REVIEW

PROPOSAL TO RESTART UNIT 2

SAN ONOFRE NUCLEAR POWER PLANT

DEFECTS IN THE STEAM GENERATOR PRIMARY CIRCUIT TUBING

FIGURE 3 RSG COMPONENT LOCATIONS

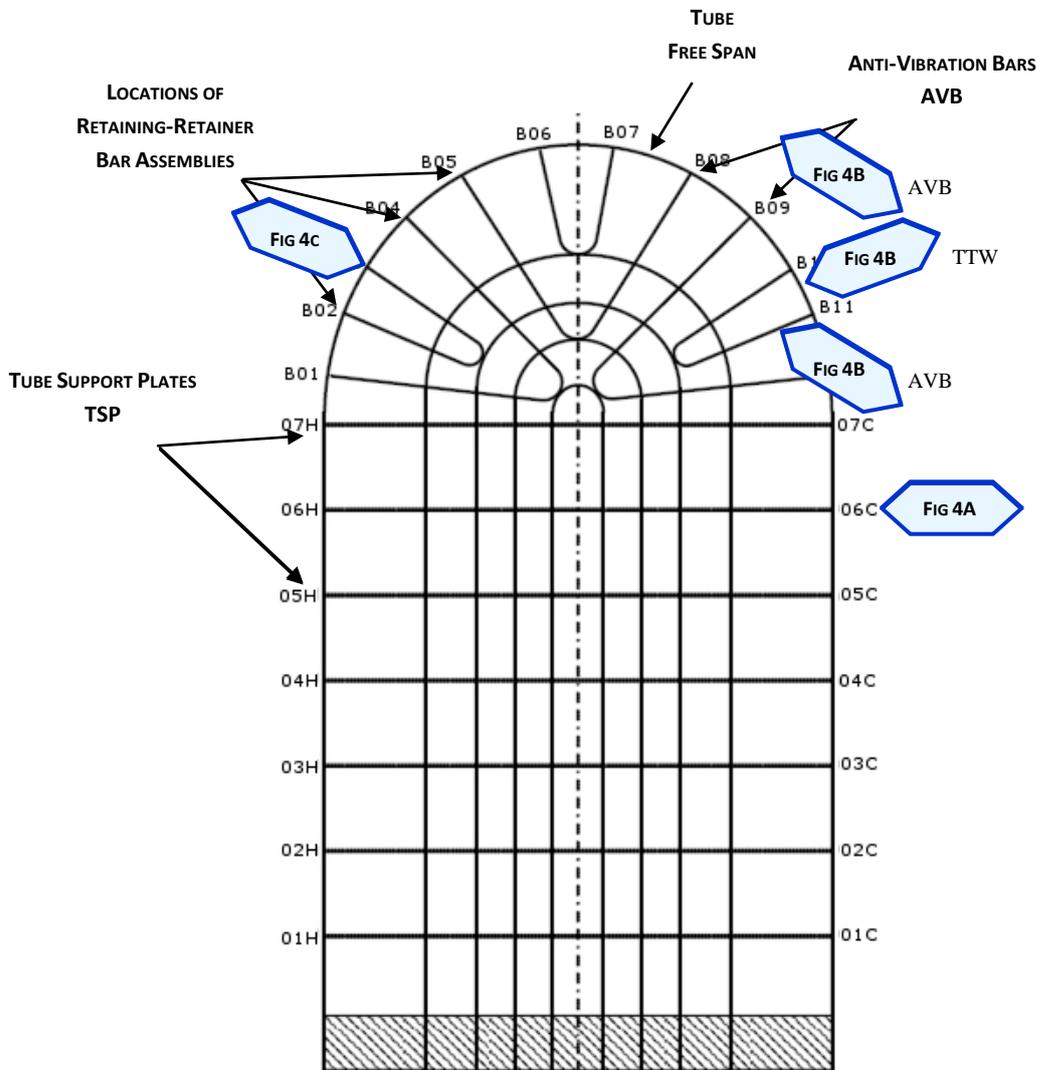
The TSPs (FIGURE 4A) and AVBs (FIGURES 4B and 4C) provide points of restraint that arrest tube motion. The arrangement of the TSPs and AVBs is shown by (FIGURE 3). The TSPs acting at seven locations along each of the hot- and cold-leg sections of the tube bundle capture the individual tubes, via a broached piercing which minimizes lateral and radial tube motions whilst allowing some flow continuity at that particular tube location. The twelve AVBs act to restrain the tubes in the *out-of-plane* (OOP) direction by the tubes reacting against the AV bar which, itself, reacts against the next and successive *rows* of tubes. In this way the system of sandwiched AVBs obtains stiffness and restraint via the collective inertia of the tube bundle. Normally, because the dominant direction of motion experienced in SG tubing is in the *out-of-plane* direction (that is the least stiff axis of the individual U-bend section of a tube), the restraint acting against tube motion in the *in-plane* (IP – along the *columns* of tubes) direction is considered of secondary importance.

FIGURE 4A TUBE SUPPORT PLATE-TO-TUBE WEAR

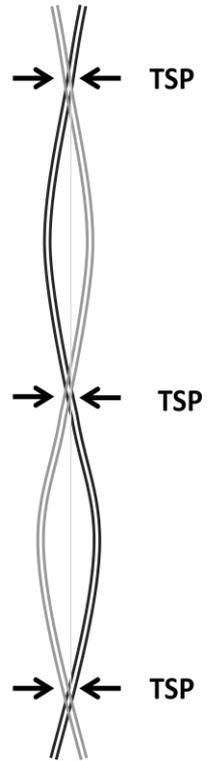
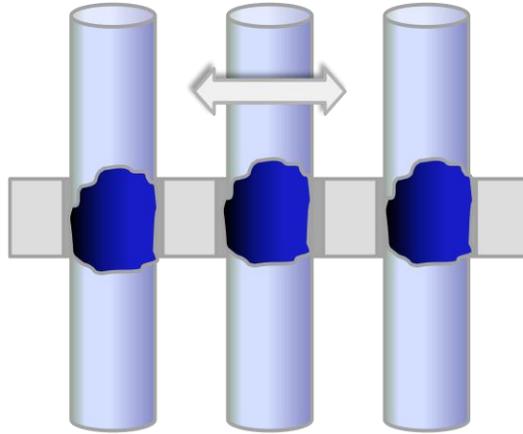
MHI considered that FEI activity was suppressed in the region of the TSP localities and that this mode of tube wear arose from cross-flow induced random vibration; the AVB-to-tube wear was also related to

FIGURE 4B AVB WEAR & AVB-TO-TUBE WEAR

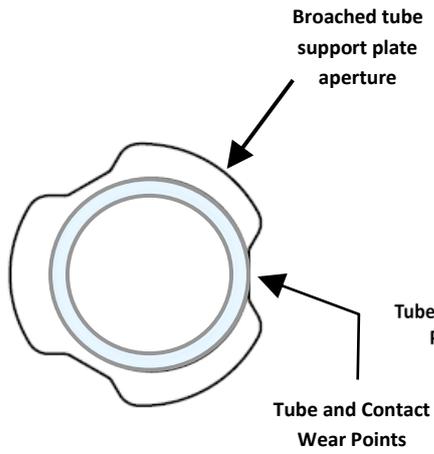
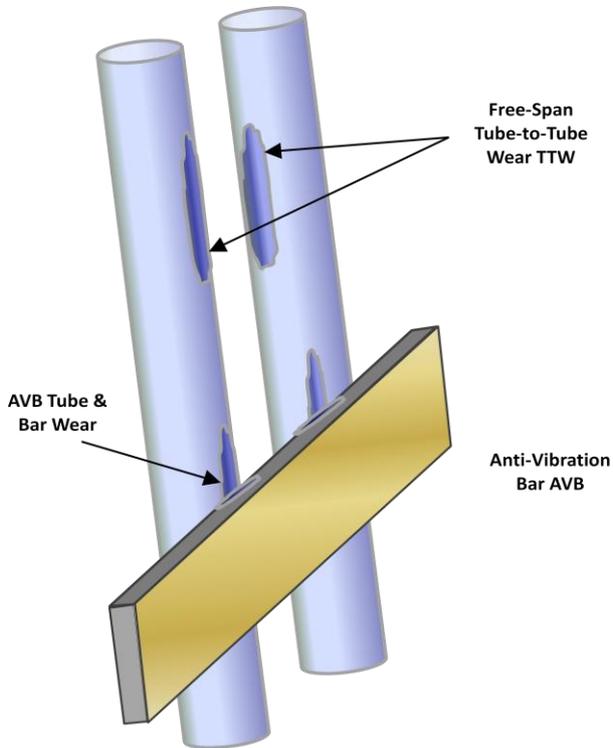
In the SONGs RSGs the AVB design strategy intended to achieve a ‘zero bar-to-tube gap’ functionality when in the hot, pressurized condition. This meant that at *zero-gap* although the AV bar and tube would be in contact, there would be no clamping or preload force present between the successive AVBs and tubes. This *zero-gap-no-contact force* functionality was to minimize point contact with the tubes and the undesirable formation of dings and dents in the tube wall but, to disadvantage, no contact force meant that the friction force restraining tube motion in the *in-plane* direction (both in-and-out and up-and-down) was also zero or minimal.

In effect, any significant *in-plane* fluid excitation force had the potential to excite individual tubes into motion in the *in-plane* direction because of the lack of *in-plane* restraint wore down the surfaces of the AVB and tube, leading to greater freedom to move in both *in-* and *out-of-plane* directions. Individual tubes so released in this way were free to vibrate and impact against neighboring tubes, with their motion similarly wearing down the AVB-to-tube restraint, thus releasing that tube to repeatedly ‘bump’ against its neighbor, eventually leading to the progressive wearing down of whatever level of unintended preload force existed at each AVB. This ‘bumping’ mechanism provides a means by which loss of AVB-to-tube effectiveness can advance through the area of the tube bundle where *in-plane* fluid forces were active – it is also characterized with a time dimension as each AVB-to-tube contact wears away and permits the individual tube motion to be transferred to its neighbor.

FIGURE 4C AVB ASSEMBLY RETAINER BAR-TO-TUBE WEAR

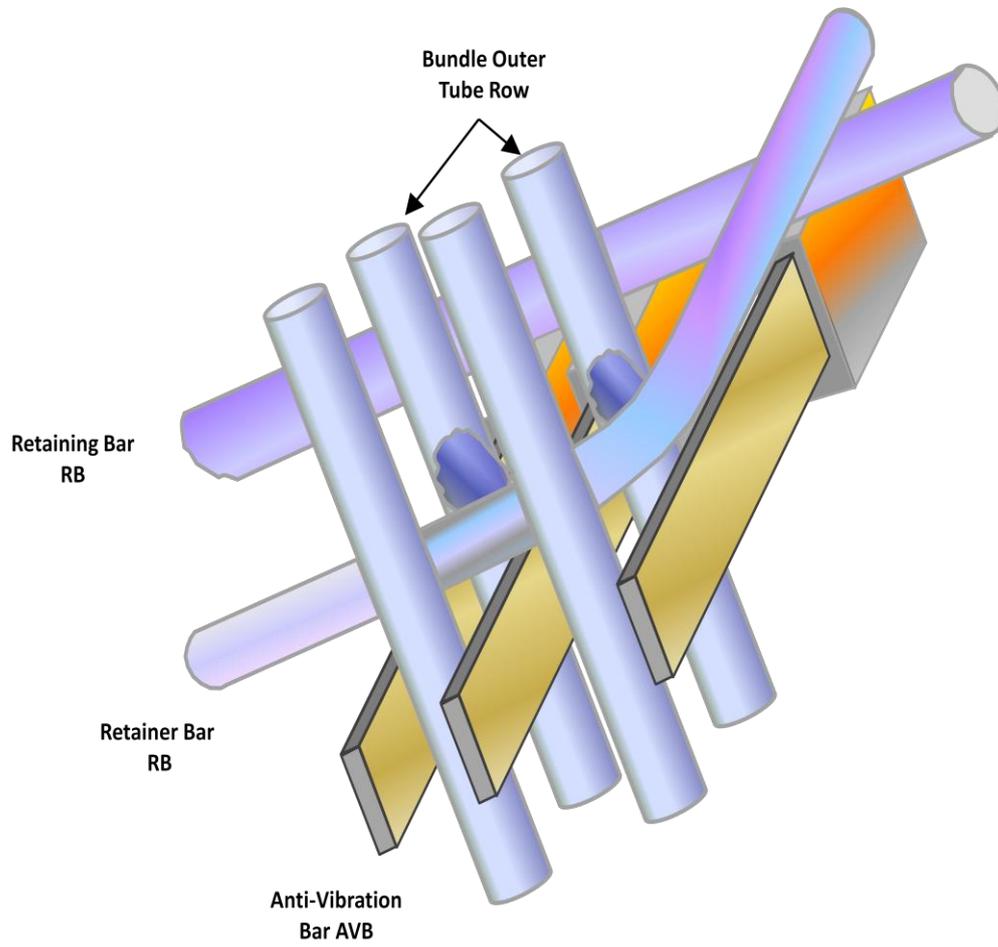
In October 2012 MHI communicated directly to NRC that the ‘*tube wear adjacent to the retainer bars was identified as creating a potential safety hazard*’, recommending that the retainer bars that have the possibility to vibrate with large amplitude should be removed {5.6.6-12}. This restraint system locates the anti-vibration bars in place during normal operation and, also, serves to contain the tube bundle geometry during a main line steam break (MSLB) design basis event.

13) This ad hoc approach to managing nuclear safety risk is entirely unsatisfactory – modification to any component of a nuclear system, especially one providing a safety function during a design basis event, should be evaluated in terms of the plant as a whole rather than, as it seems to be the case here, in isolation to other components of and without regard to the overall safety function of the RSGs themselves.
